**Luminant**

**Rafael Flores**  
Senior Vice President  
& Chief Nuclear Officer  
Rafael.Flores@Luminant.com

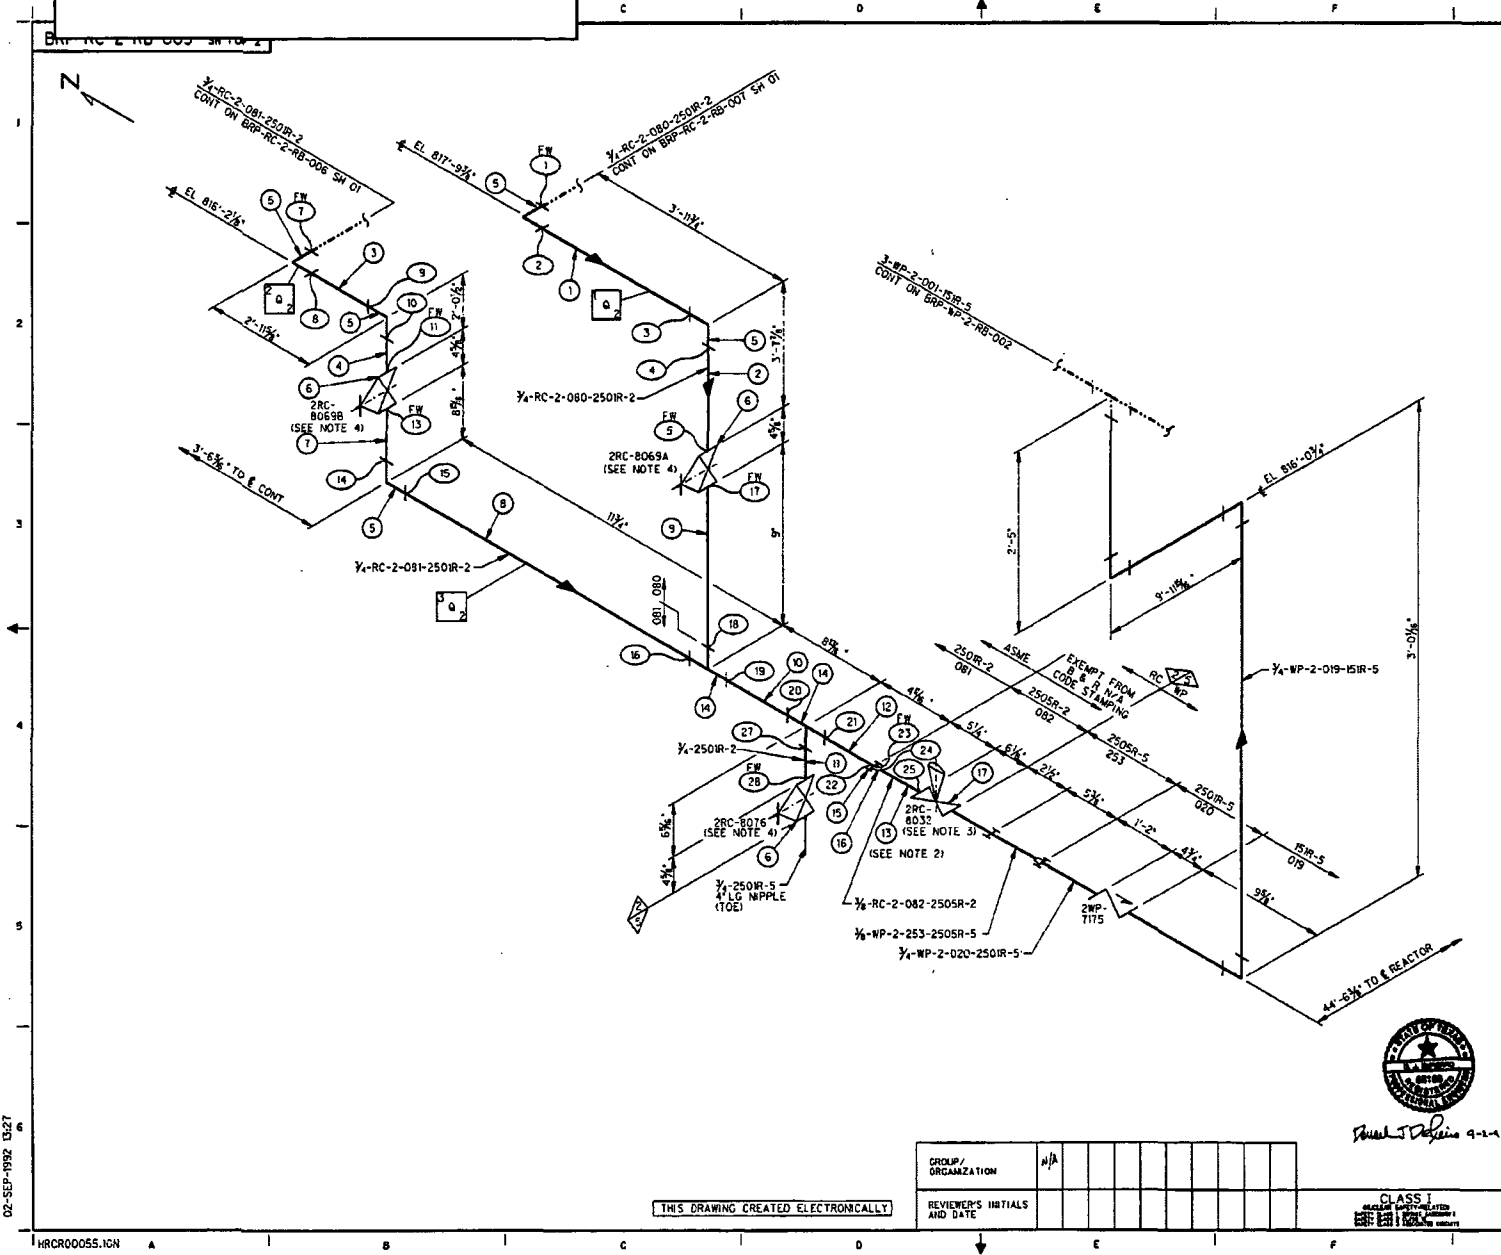
REV	DATE	BY	CHKD	APPV	REMARKS
CP-6	10/15/02	CP	CP	CP	THIS DRAWING REVISED TO INCORPORATE H-S PUNCHLIST COMMENT AND NOTED.

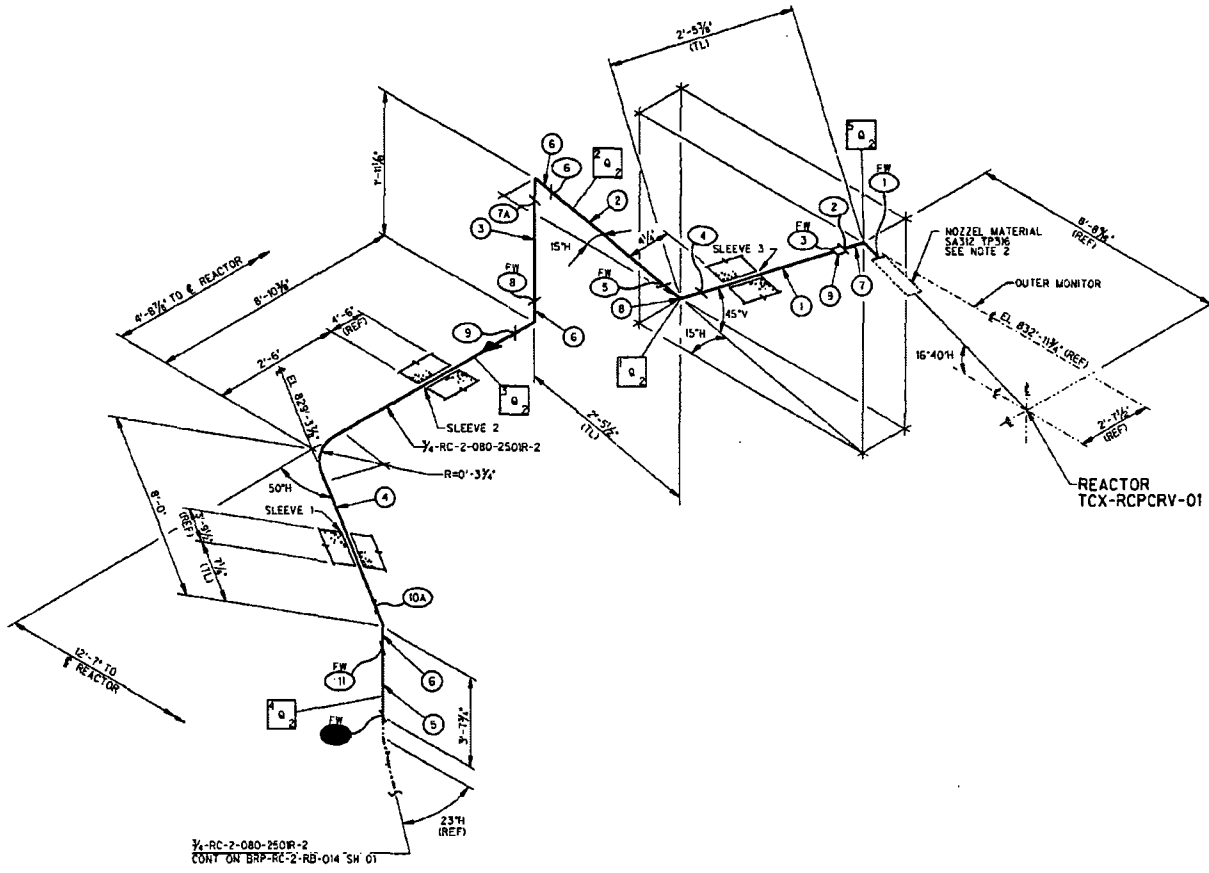
REV	DATE	BY	CHKD	APPV	REMARKS
2	10/22/92	WPS	WPS	WPS	THIS DRAWING REVISED TO INCORPORATE W-9 PURCHASER COMMENTS.
